Glenunga 1852 001

26 February 2020

**Draft Planning & Design Code – Phase Three (Urban Areas)**

I make the following submission on behalf of my Client, Mr Marc Kovacic in relation to proposed policies within the draft Planning and Design Code – Phase Three (Urban Areas) as such relate to the future development of land located at 499 Portrush Road, Glenunga.

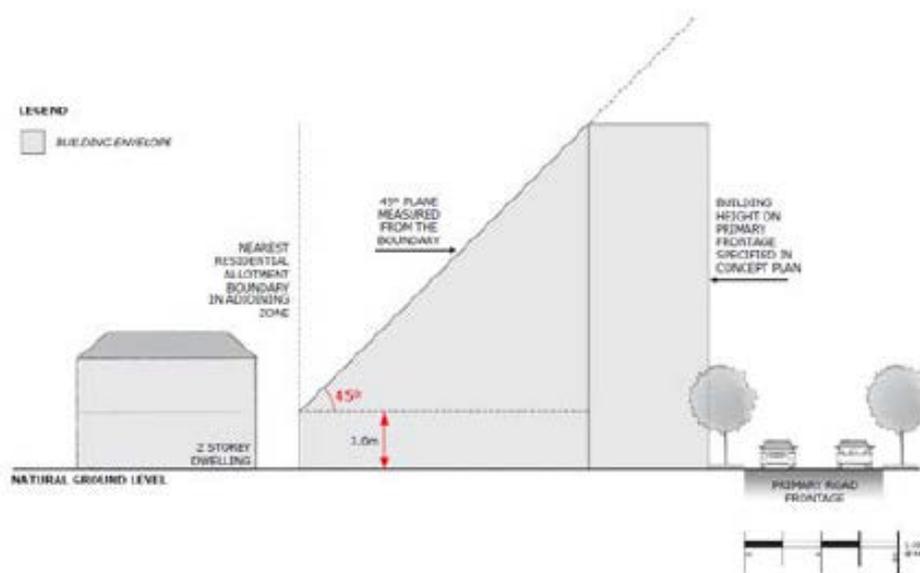
The form of building mooted for this land is significantly in excess of this size such that will have profound amenity impacts on adjoining land in terms of the bulk and visual scale of the structure relative to the rear gardens of adjacent residential properties. This fundamental planning consideration should not be overlooked.

The recent development application by Aldi failed these fundamental planning tests.
